1663A TYPE TEL SET CONNECTING DIAGRAM

DWG SIZE 6S | CDS | A-580215

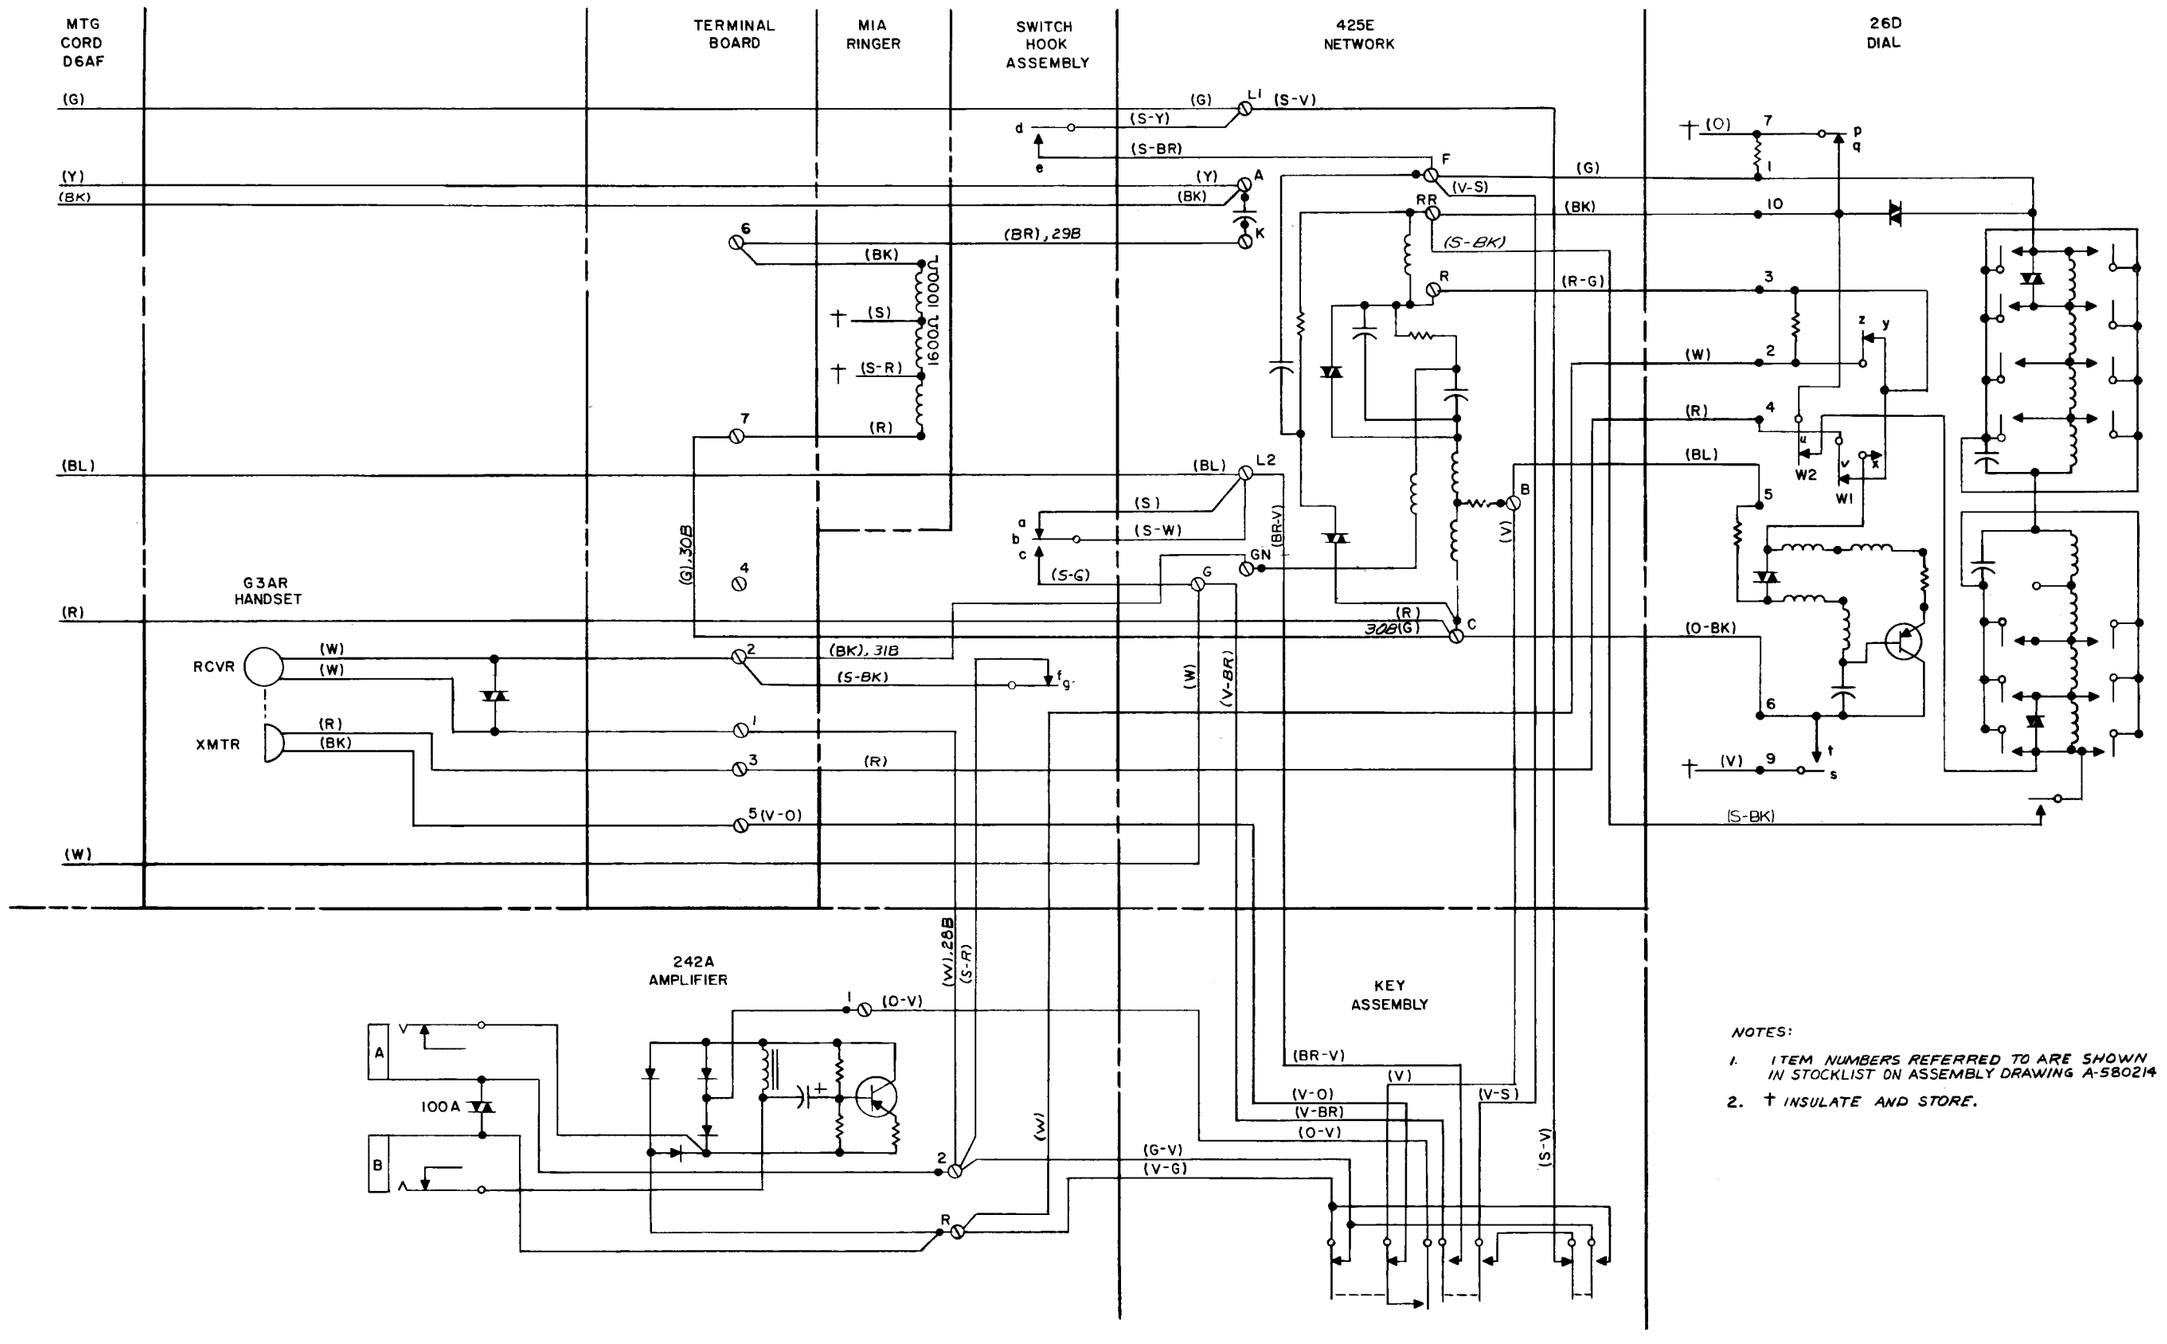
9-18-63 ISSUE-1
CHANGED: P & Q DIAL CONTACTS WERE OPEN. ADDED: RESISTOR BETWEEN 7 & 1 IN 26B DIAL PORTION.
KSR 591822-BIL
1-28-64 MLT 2
CHANGED: 26D DIAL INFO WAS 26B DIAL INFO; S-BK LEAD FROM DIAL WAS COMM TO TERM P OF NETWORK.
KSR 443602-AK-G
6-3-64 3
